ADMINISTRATIVE REPORT

Title: DAV 25-117254\C – 436 Balmoral Street

Issue: For a Variance associated with an 18-storey 150-unit multi-family dwelling.

FLOOR (-2) - BASEMENT PLAN

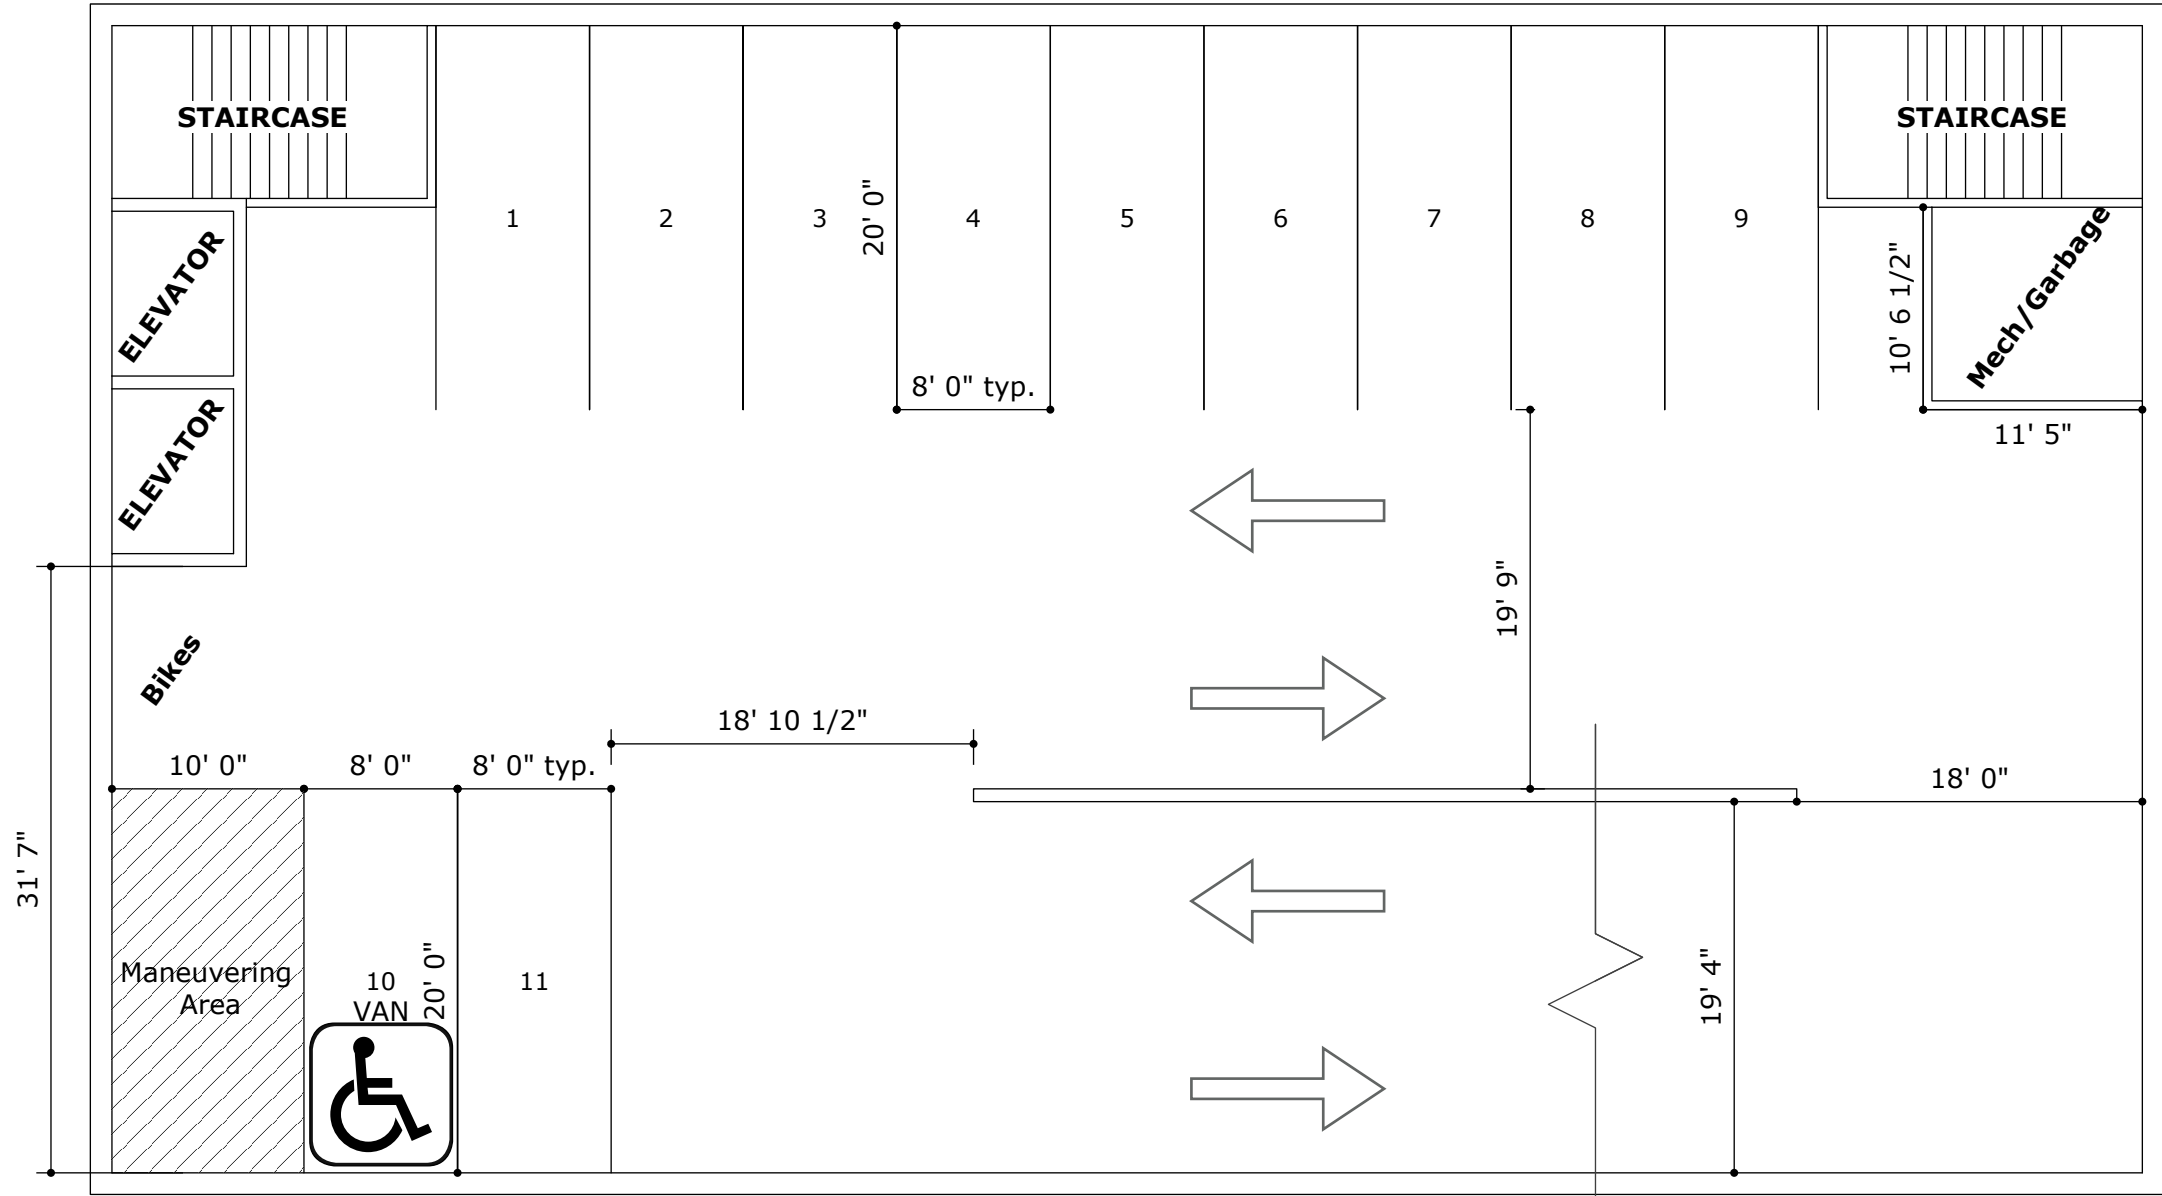
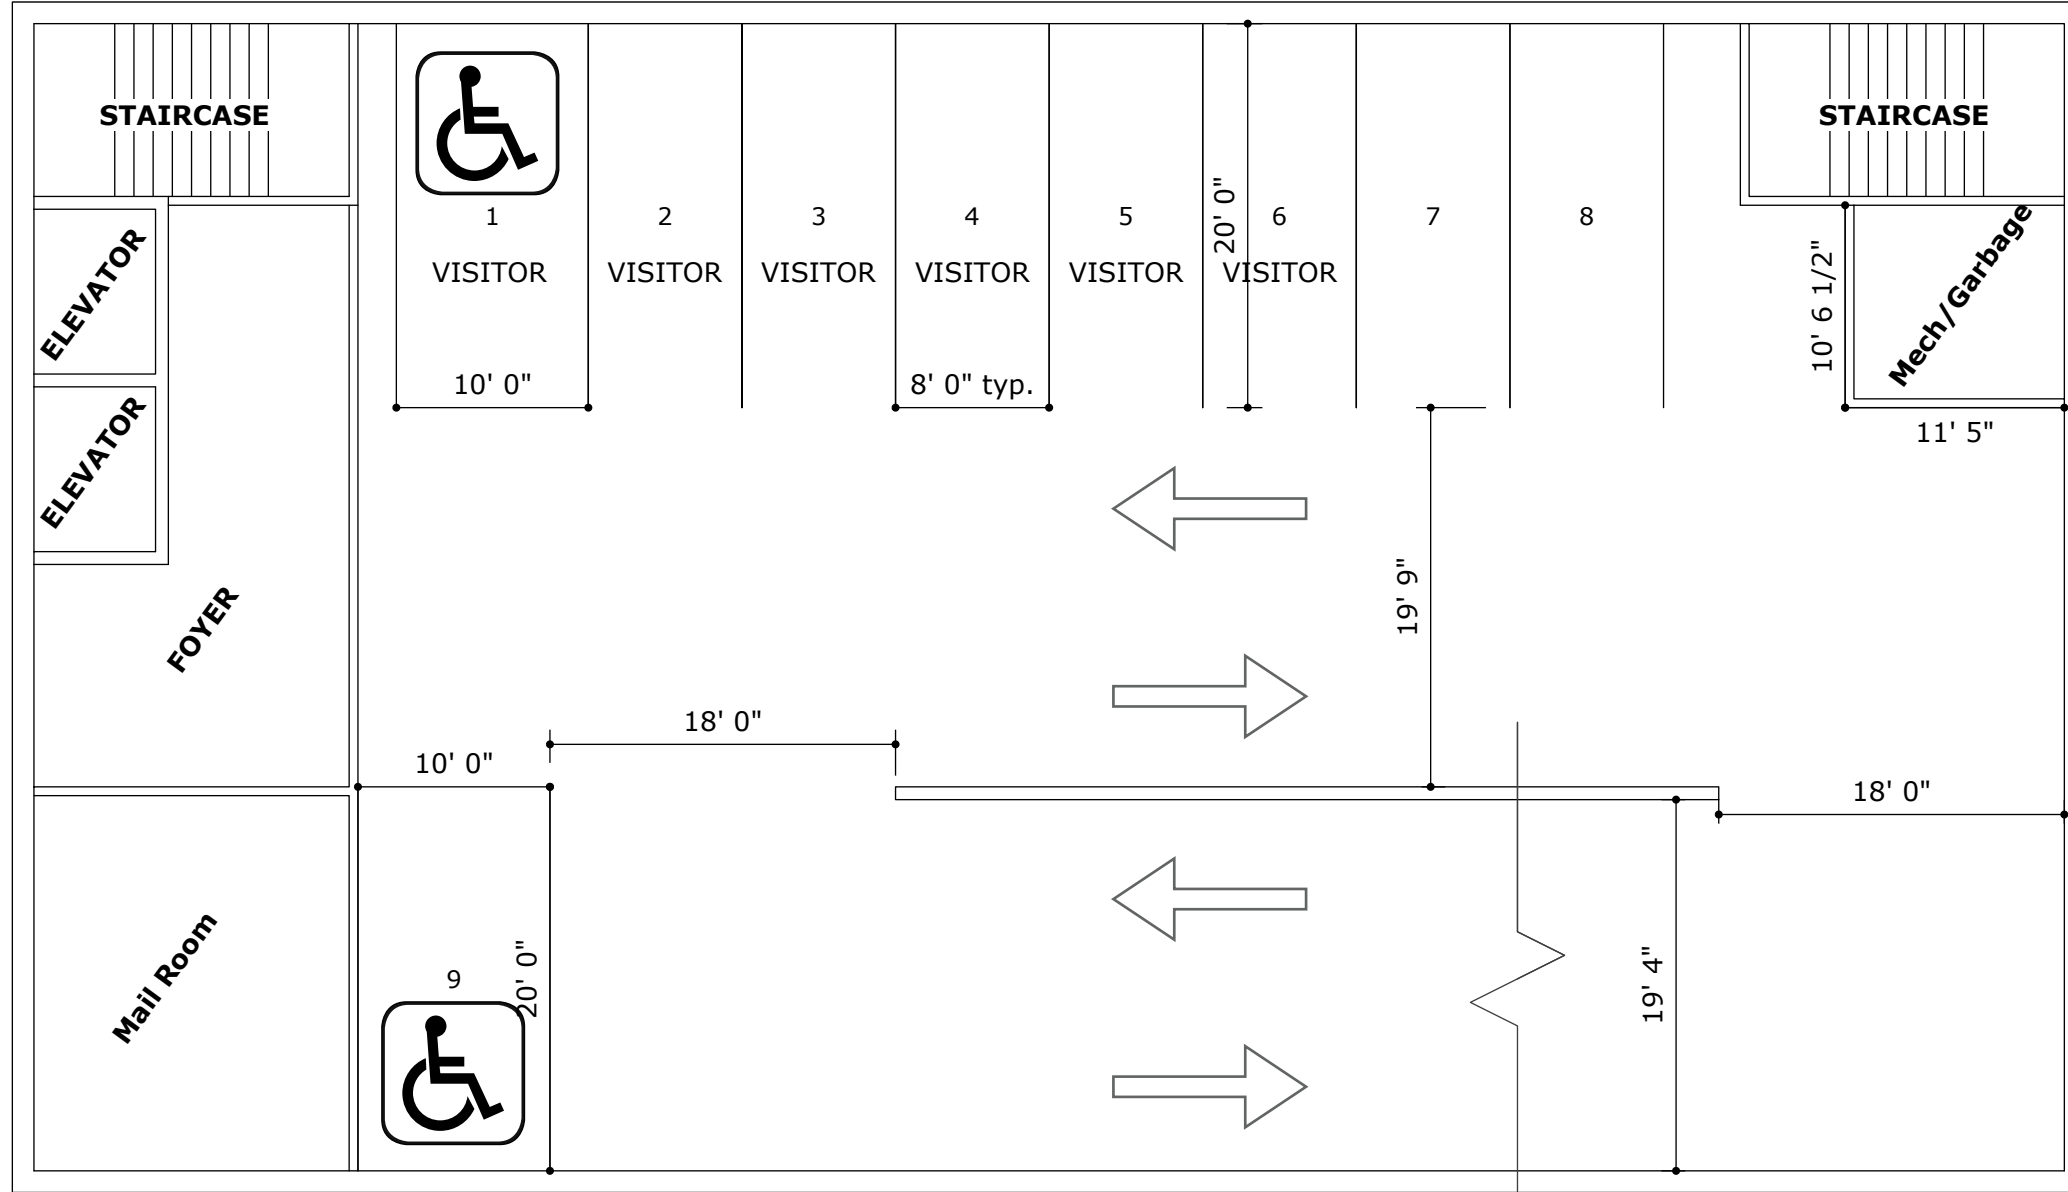
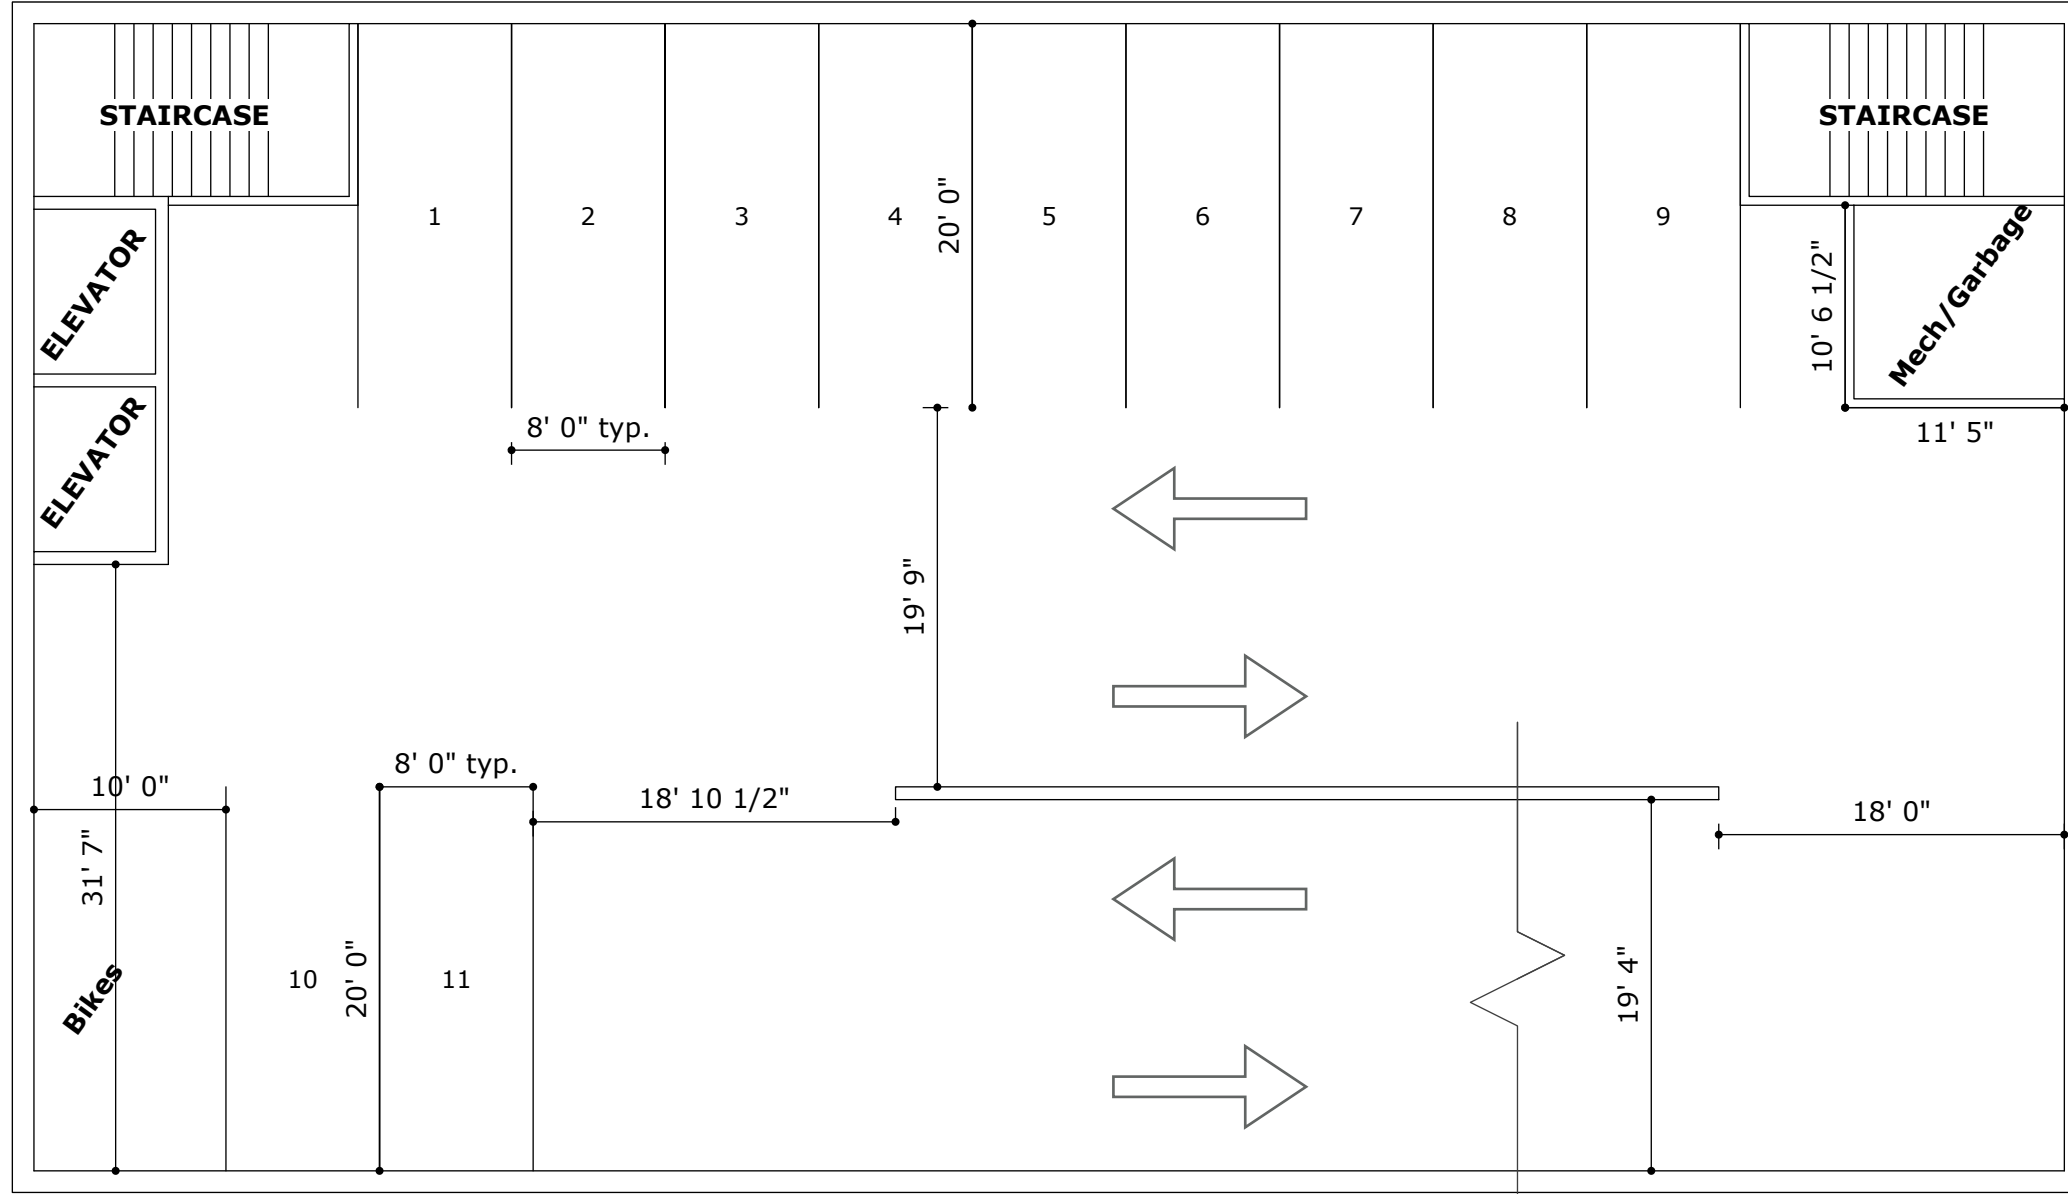
Reduced Parking:

- With the rationale that this area of the city is pedestrian, bike, and transit friendly, a parking reduction is not uncommon, however, a parking reduction of this magnitude (58 spaces instead of required 186 (36 for proposed Lot 1 and 150 for proposed Lot 2) would typically only be supported with the provision of affordable housing and car share vehicle(s) in addition to indoor bike parking.
 - The proposal does not provide parking offsets, such as affordable housing and car share vehicle(s) and thus the Division does not support this Variance.

Substandard Drive Aisles:

- The minimum 20-foot parking aisle aides in the safe and efficient maneuvering and movement of vehicles when there is two-way traffic.
- The substandard drive aisle widths potentially pose adverse effects for drivers moving in/out of the proposed development for Lot 2 as well as potentially impacting the safety of residents, guests, and others who will move in/around the parking areas and for those who will use the off-street parking spaces. Although 18 feet is a minor Variance it must be viewed together with the other requested Variances for this application.
